Model: Moto Guzzi V85 TT Euro 5

Subject: Intake valve - Technical update

Campaign Code: PG2ZZQ2103

Below is an operational diagram for the management of the operations

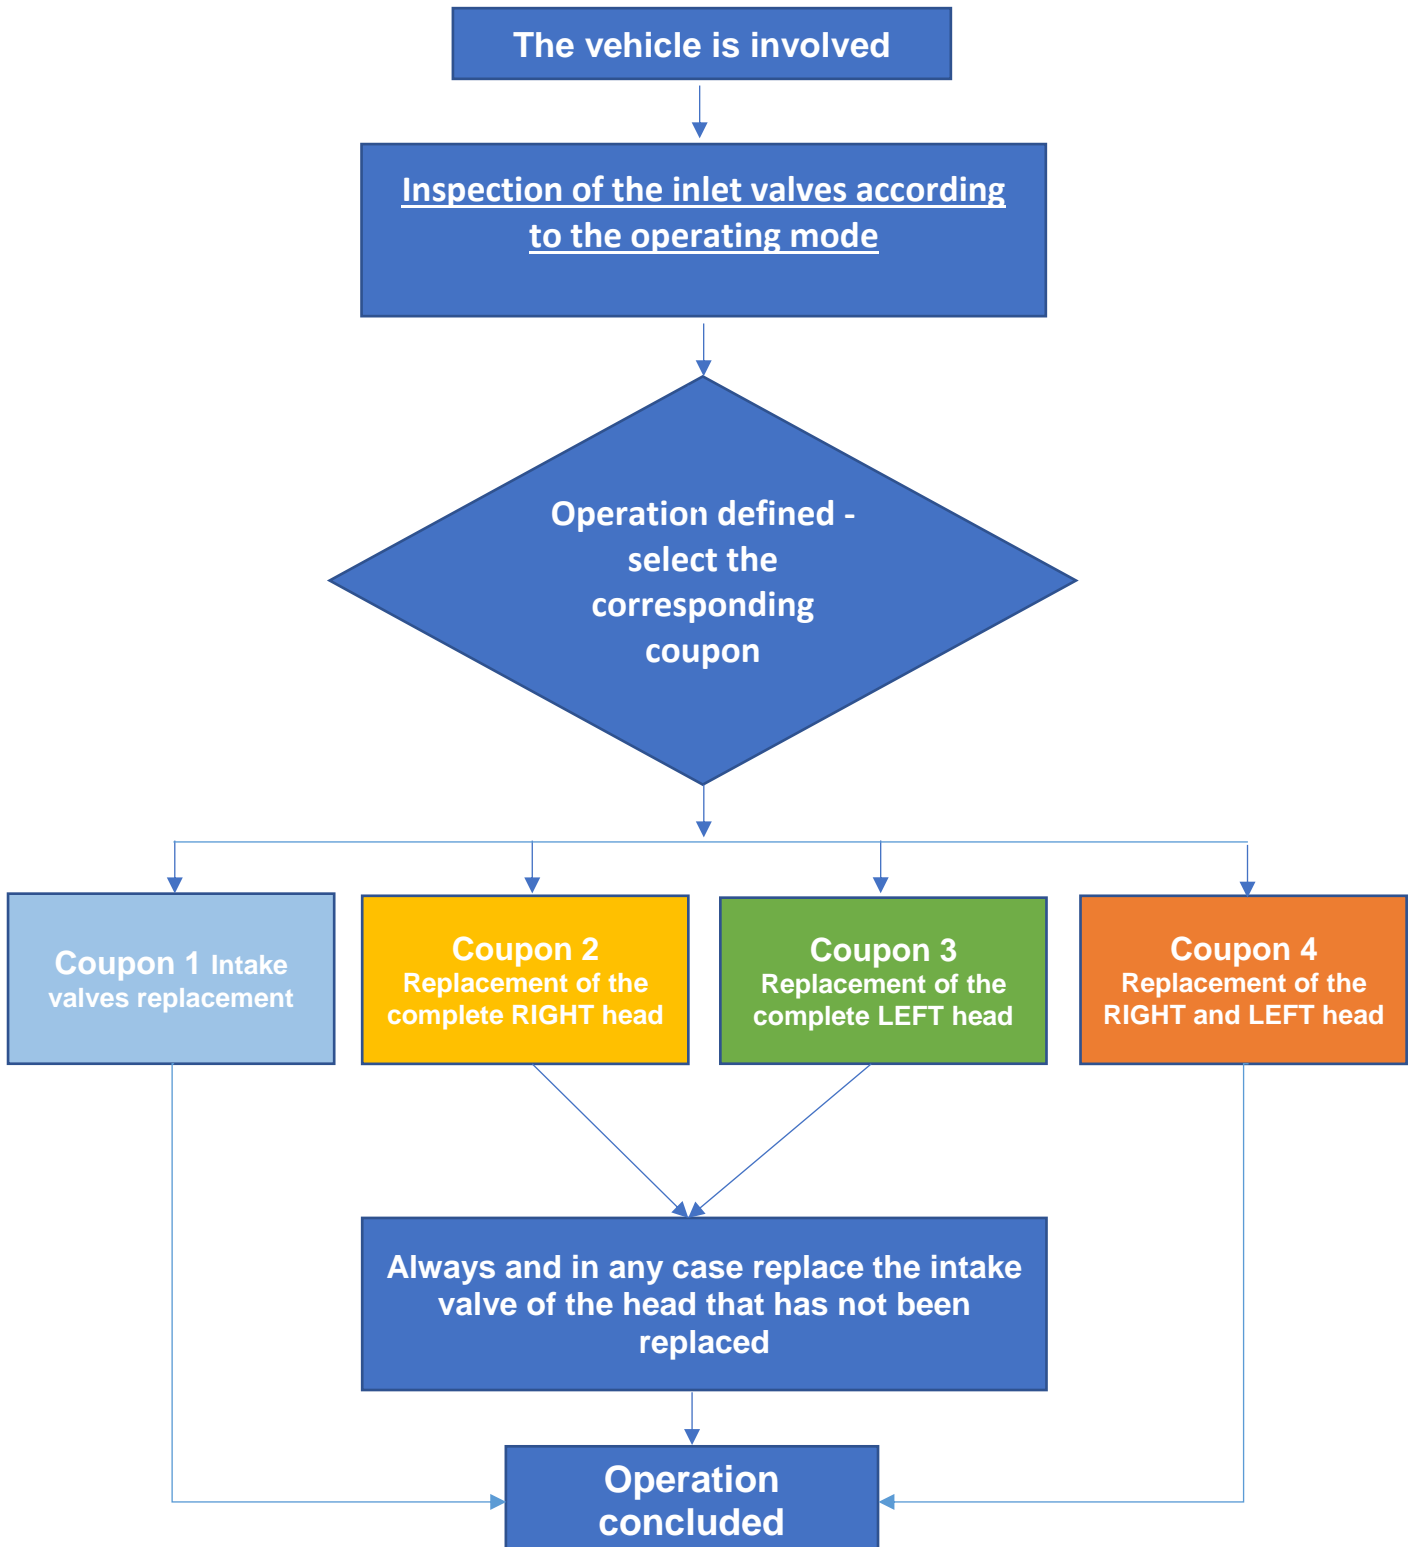
- **By selecting Service Coupon 2 or Service Coupon 3, the intake valve of the head that has not been replaced must also be replaced.**
- **The coupons include the insertion of the photo of the damaged valves.**
- Select the coupon, compile the “**Km**” field, and then save the procedure. Please note that to complete the operation and receive a refund, the coupon must be declared "completed" (from the PWM status management) within 6 months from the day of entry.
